SAFETY EVALUATION REPORT
RELATED TO THE TOPICAL REPORT FOR THE FOSTER WHEELER MODULAR
VAULT DRY STORE (M.V.D.S.) FOR IRRADIATED NUCLEAR FUEL

U.S. Nuclear Regulatory
Commission

March 1988

SUBJECT: LIMITED PROPRIETARY REVIEW OF NUCLEAR REGULATORY COMMISSION (NRC) STAFF'S FINAL SAFETY EVALUATION REPORT (SER) FOR THE FW ENERGY APPLICATIONS, INC., TOPICAL REPORT FOR THE FOSTER WHEELER MODULAR VAULT DRY STORE (M.V.D.S.) FOR IRRADIATED NUCLEAR FUEL, REVISION 1

Figure 1.2.5-1 Arrangement of Load/Unload Port & Mod. to Cask Inner Closure

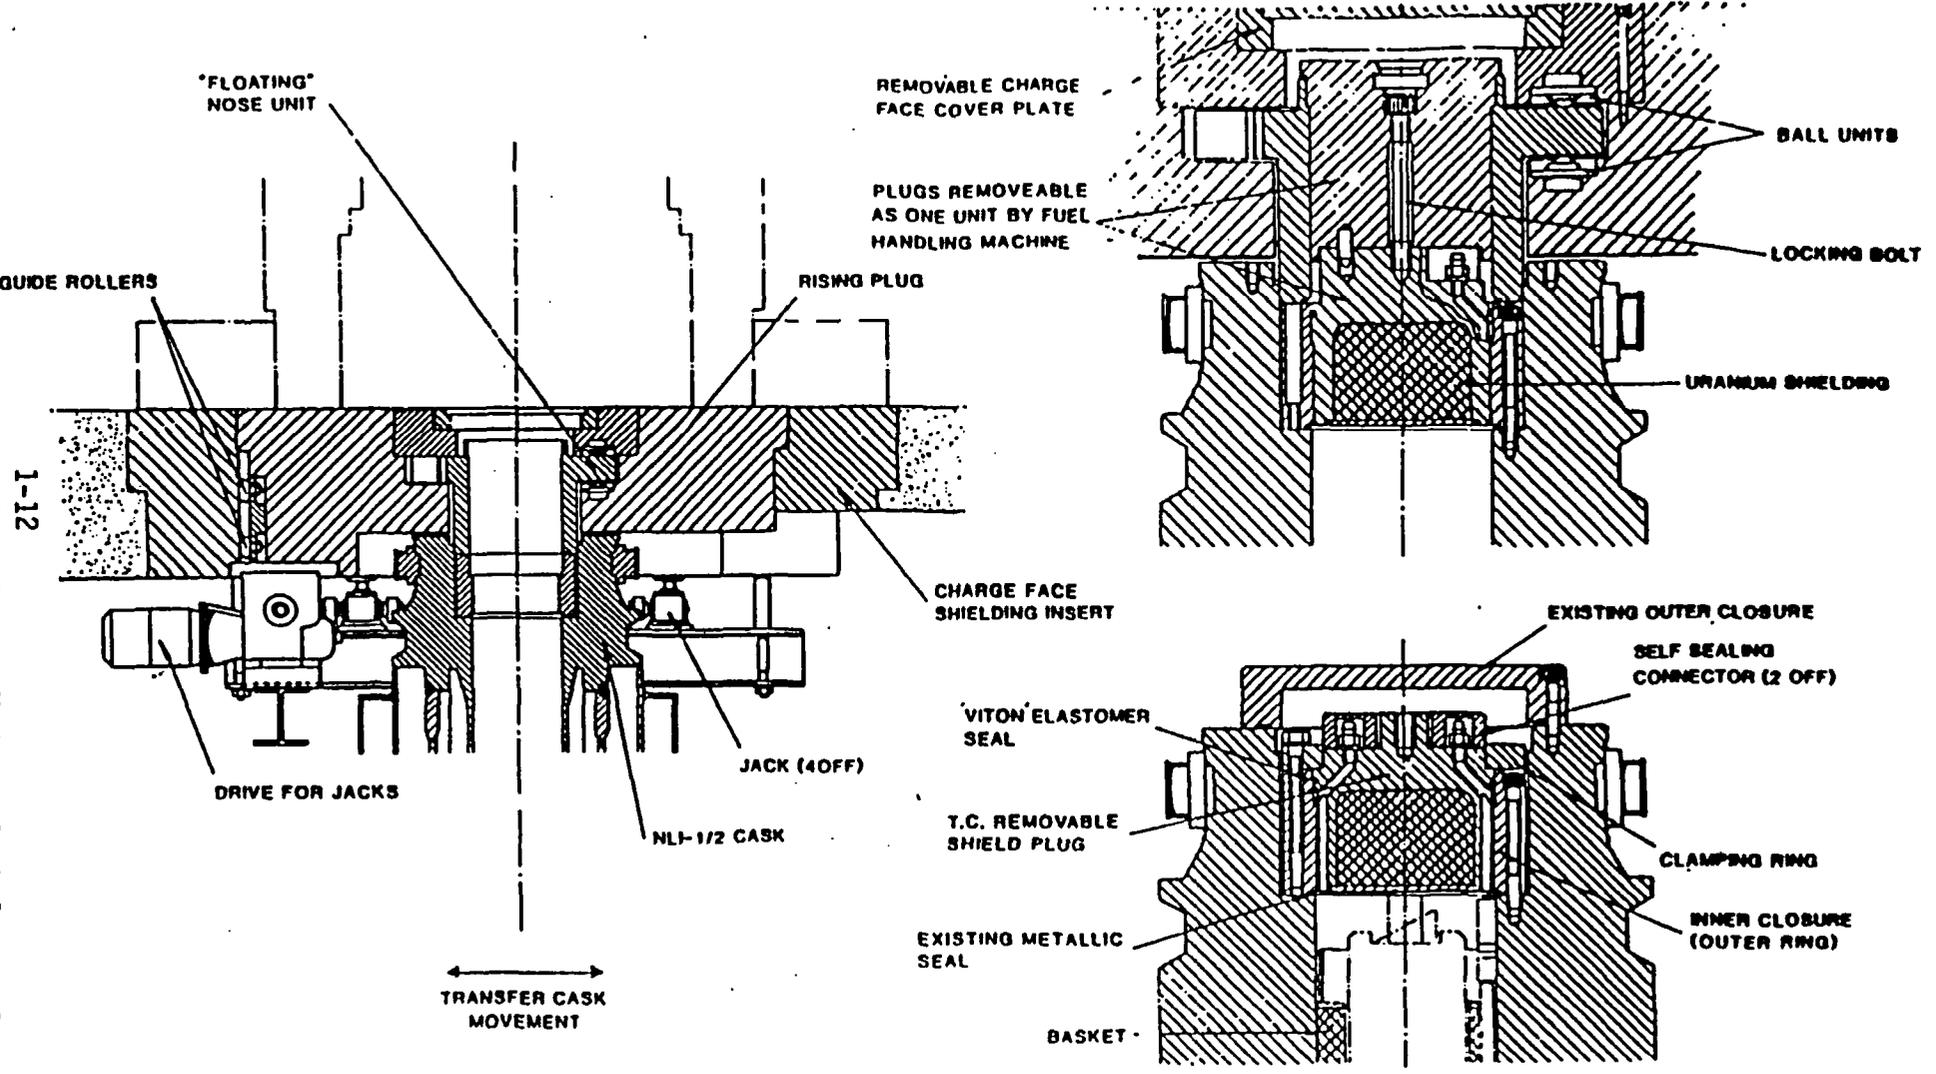
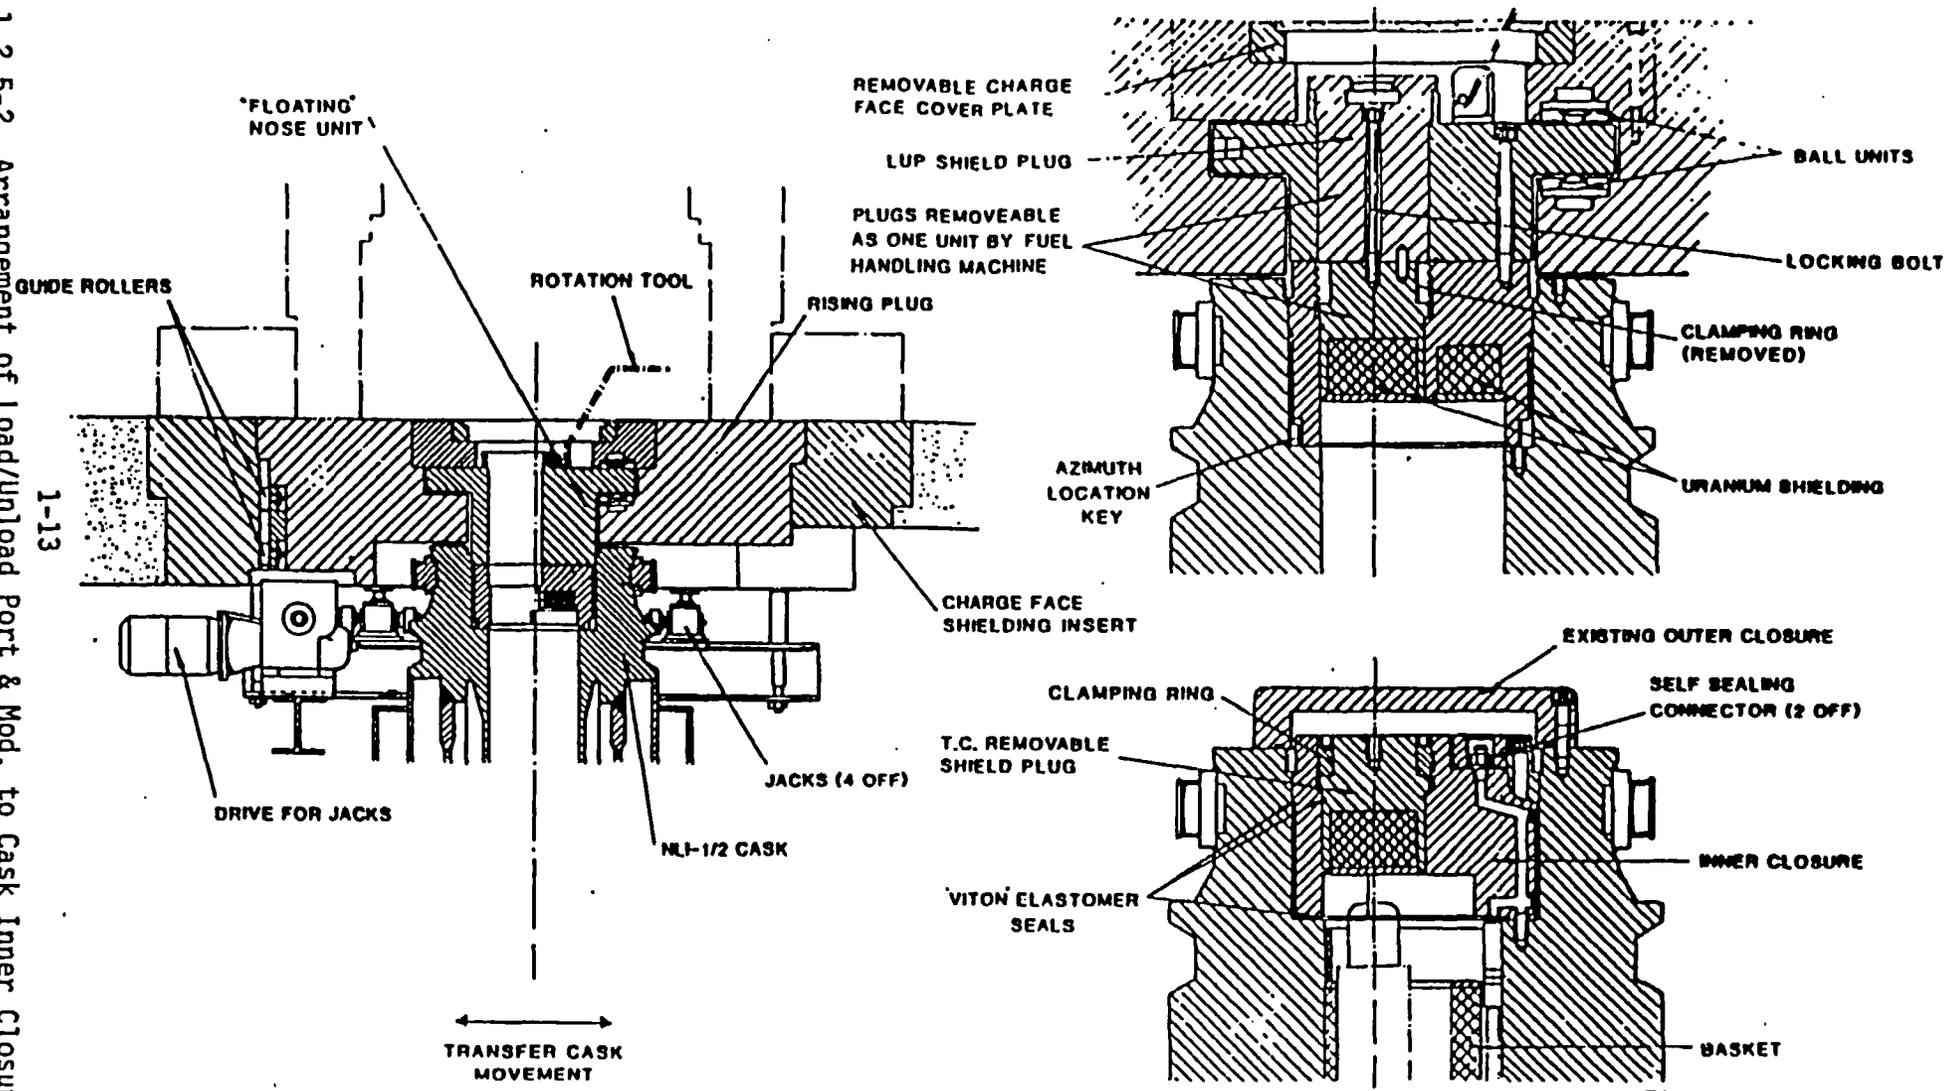
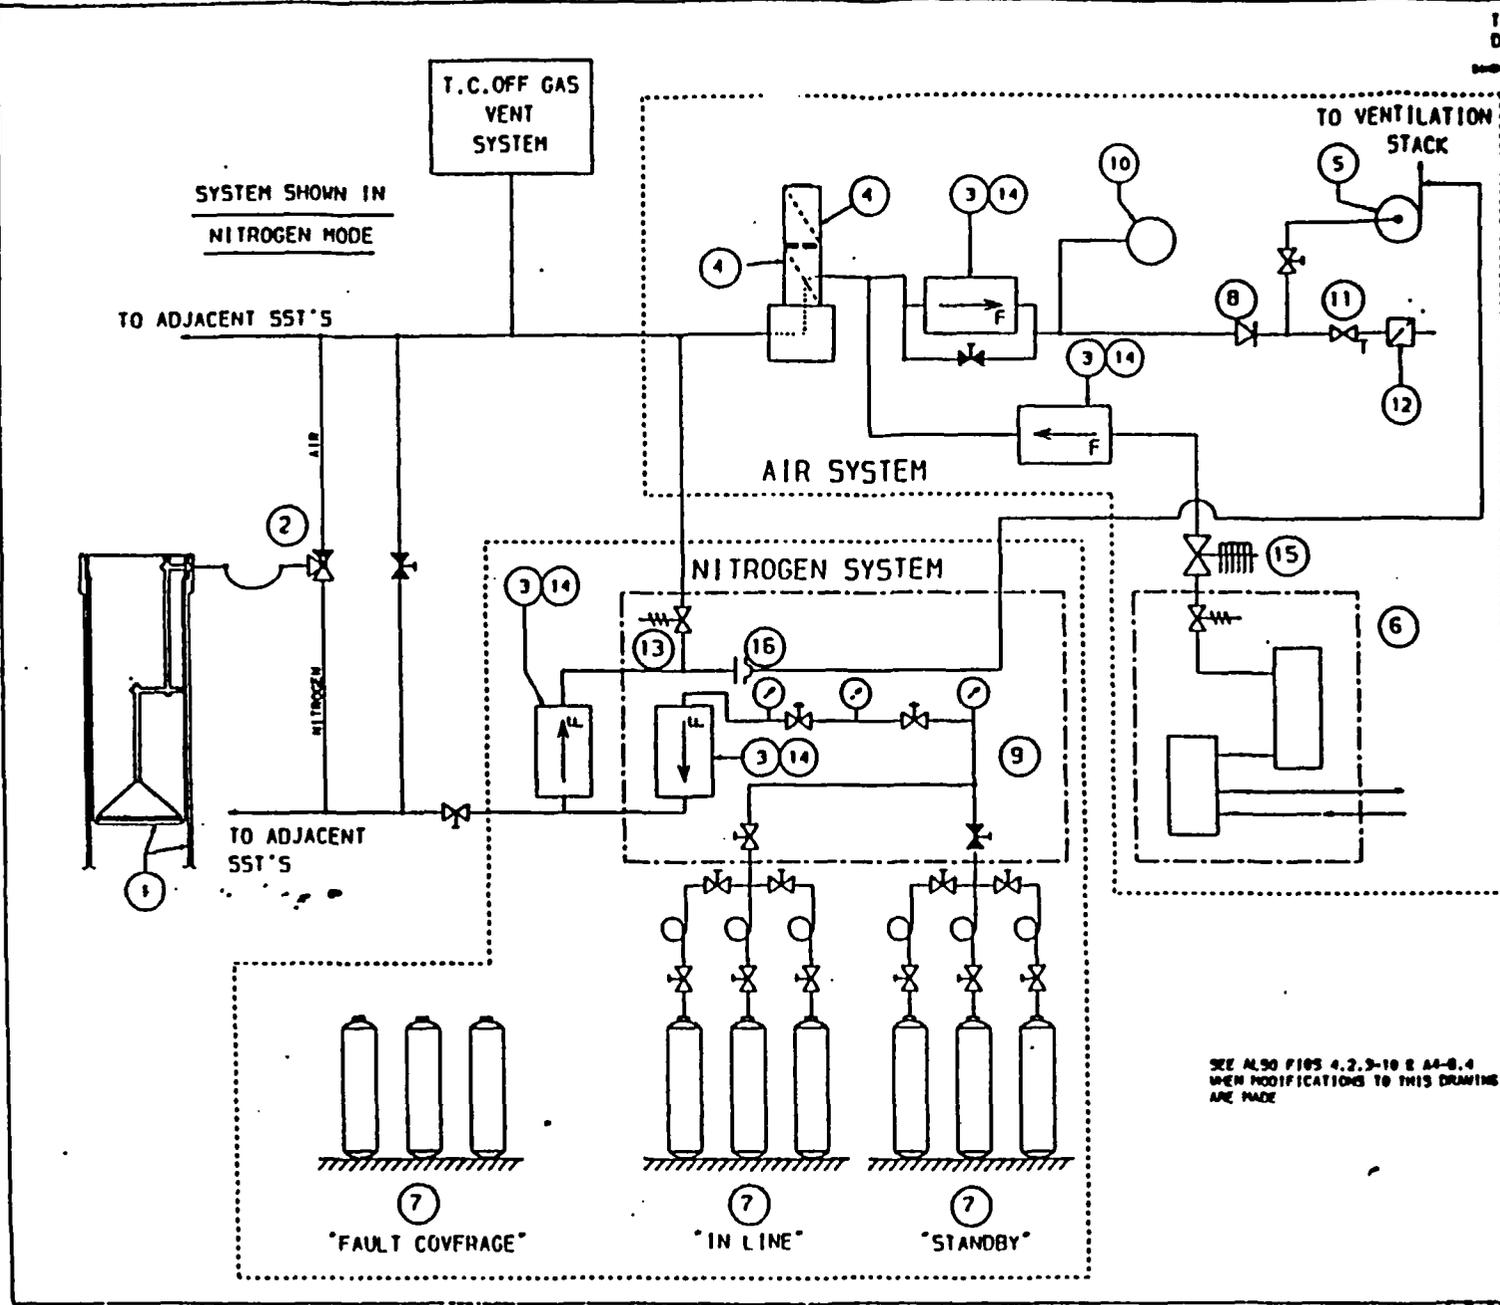
The maximum internal pressure limits for the standard NLI 1/2 cask should be applicable to the MVDS cask with a modified closure. FW did not provide internal pressure criteria for the standard cask. However, calculations provided in the TR identify maximum pressure limits to prevent lifting of an unbolted closure. The unbolted closure configuration is used inside the TCRB. The check that FW made was to ensure that any internal pressure build up during movement of the cask on the trolley would not result in lifting of the unbolted closure. During cask movement on the transportation trailer outside the MVDS, the modified closure is securely bolted to the TC. For this case, FW determined that the cask internal temperatures and associated internal pressures would result in insignificant loads on the closure bolts and retaining ring.

The gamma source terms for PWR and BWR IFAs are taken from ANS 57.9, Appendix B. Dose rates at various positions on the standard NLI 1/2 cask closure were obtained from the NLI 1/2 cask report and certificate of compliance 9010, based on fuel cooled for 150 days and 120 days respectively for PWR and BWR fuel. Dose rates from the certification report were scaled for comparison with dose rates at similar positions on the MVDS NLI 1/2 cask modified closure, including seal locations, considering a longer fuel cooling time (5 years) for the MVDS condition. The staff considers these criteria acceptable. Table 2.4.5-1 summarizes the criteria for normal operations for the TC lid modifications.

The 3.21 psig pressure is the minimum pressure that would cause the modified cask inner closure for the BWR configuration to lift after the closure is unbolted at the TCRB (the PWR lifting pressure is 4.37 psig). This pressure is correlated to the maximum increase in ambient temperature that can be tolerated at steady state by the NLI 1/2 cask prior to closure removal. This condition is pessimistic due to the requirement to vent the cask prior to unbolting the closures. These criteria are considered acceptable by the staff. Table 2.4.5-2 summarizes the criteria for off-normal operations for the TC lid modifications.

The closure bolts and clamping rings, which form part of the modified NLI 1/2 cask closure configuration, must have an equivalent ability to withstand accidental impacts as the original design. The worst impact scenario considered is a failure of the cask lifting system while the cask is being lifted to a vertical position. The cask would pivot about the lower trunnions and "slap down" on the roadway, causing the cask contents to hit the underside of the closure. The criteria specified for IFA weights, closure-to-IFA clearance and construction material allowables, as identified in Table 2.4.5-3, are acceptable to the staff.

The elastomer seals form part of the modified cask closure configuration. The most severe condition that the modified seal could potentially experience is a fire during transport. The allowable maximum temperature of 200 degrees C is an acceptable criteria for the modified seal configuration.
